Staff Report & Recommendation Historic Preservation Board

SUBJECT: HPB21-0482, **1300 Lenox Avenue.**

The applicant has submitted plans entitled “1300 Lenox”, as prepared by Domaine Public Architects, dated January 18, 2022.

Structural modifications and elevation

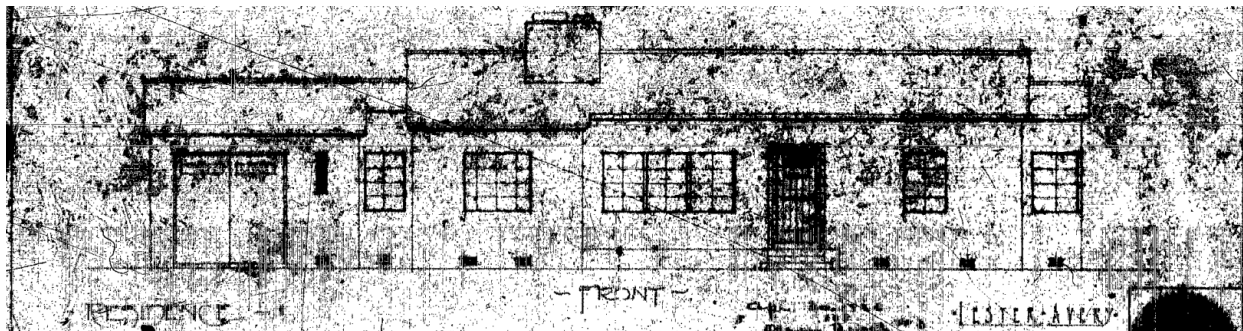
The applicant is proposing a significant renovation of the existing residence, including the elevation of the floor slab and roof structure approximately 3'-2" to make the home more resilient for the future. Structural modifications include the reinforcement of the existing foundation with helical piles, the removal of the existing floor slab (located at 6.00' NGVD) and the construction of a new floor slab within the existing building walls (at an elevation of 9.20' NGVD). Additionally, the exterior walls are proposed to be extended vertically and the window and door openings will be vertically relocated. A new roof structure, matching the design of the existing roof, will be constructed and the grade elevation of the site is proposed to be raised.

Staff would note that this type of "adapt in place" intervention is consistent with the recommended strategies identified for the Flamingo Park Local Historic District in *Buoyant City – Historic District Resiliency and Adaptation Guidelines*. The Board unanimously recommended in favor of these guidelines and were adopted by the City Commission. Staff is supportive of the structural modifications and would note that while the level of intervention is extensive, the modifications will ensure the preservation of the home for the future.

Originally designed south elevation drawing, permit no. 8214

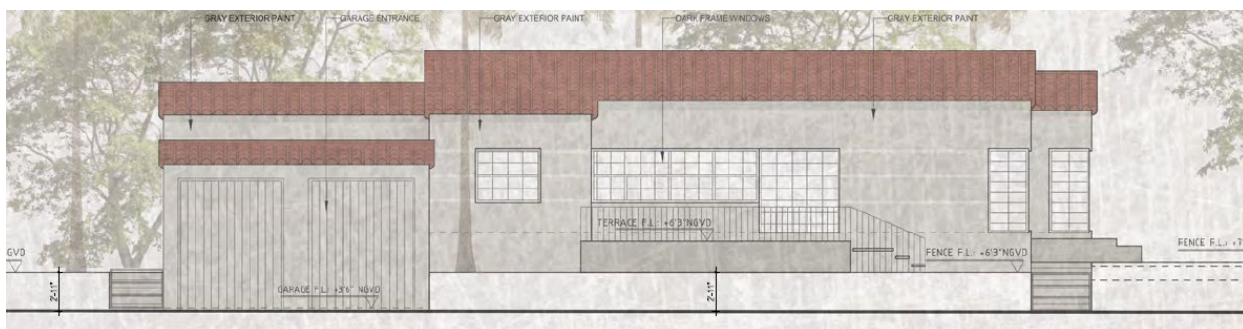
The applicant is proposing to partially restore the house including the removal of the non-original front porch structure (constructed in 1944). A small addition is proposed to be constructed at the north side of the home and a 2-car garage is proposed to be constructed in front of the existing 1-car garage along 13th Street. Staff has no objection in concept with the proposed additions, staff would however, recommends that the new garage addition be further refined in manner more consistent with the original design. This could include wider areas of masonry on the sides of the addition and a slight reduction in height of the garage doors. In order to implement the additional masonry staff would have no objection to a minimal extension of the garage further to the west.

Additionally, the applicant is proposing modifications to several of the door and window openings. In comparing the original and proposed elevations, staff has identified a number of openings that differ in proportion to the original openings. As such, staff recommends that all window openings be proportionate to original window design. Regarding the front door and windows adjacent to the left, staff recommends that these elements be restored consistent with available historical documentation to the greatest extent possible. Finally, staff recommends that the applicant explore the reintroduction of the chimney.

1. Revised elevation, site plan and floor plan drawings shall be submitted and, at a minimum, such drawings shall incorporate the following:
 - a. The existing single family home shall be fully renovated and restored, in a manner to be reviewed and approved by staff consistent with the Certificate of Appropriateness Criteria and/or the directions from the Board; at a minimum, this shall include the following:

- i. All windows shall be impact resistant casement or fixed in type and shall incorporate a muntin configuration consistent with available historical documentation, in a manner to be reviewed and approved by staff consistent with the Certificate of Appropriateness Criteria and/or the directions from the Board. The frame shall be clear anodized aluminum and the glass shall be clear with the minimum tint required by energy codes.

- ii. The applicant shall further refine the design of the windows so that they are proportionate to original window openings, in a manner to be reviewed and approved by staff consistent with the Certificate of Appropriateness Criteria and/or the directions from the Board.

- iii. The front door opening and the adjacent window to the left shall be reintroduced in a manner consistent with available historical documentation, in a manner to be reviewed and approved by staff consistent with the Certificate of Appropriateness Criteria and/or the directions from the Board.

- iv. The design of the new 2-car garage shall be further refined in manner more consistent with the original design, in a manner to be reviewed and approved by staff consistent with the Certificate of Appropriateness Criteria and/or the directions from the Board.

- v. The applicant shall explore the reintroduction of the chimney structure, in a manner to be reviewed and approved by staff consistent with the Certificate of Appropriateness Criteria and/or the directions from the Board.
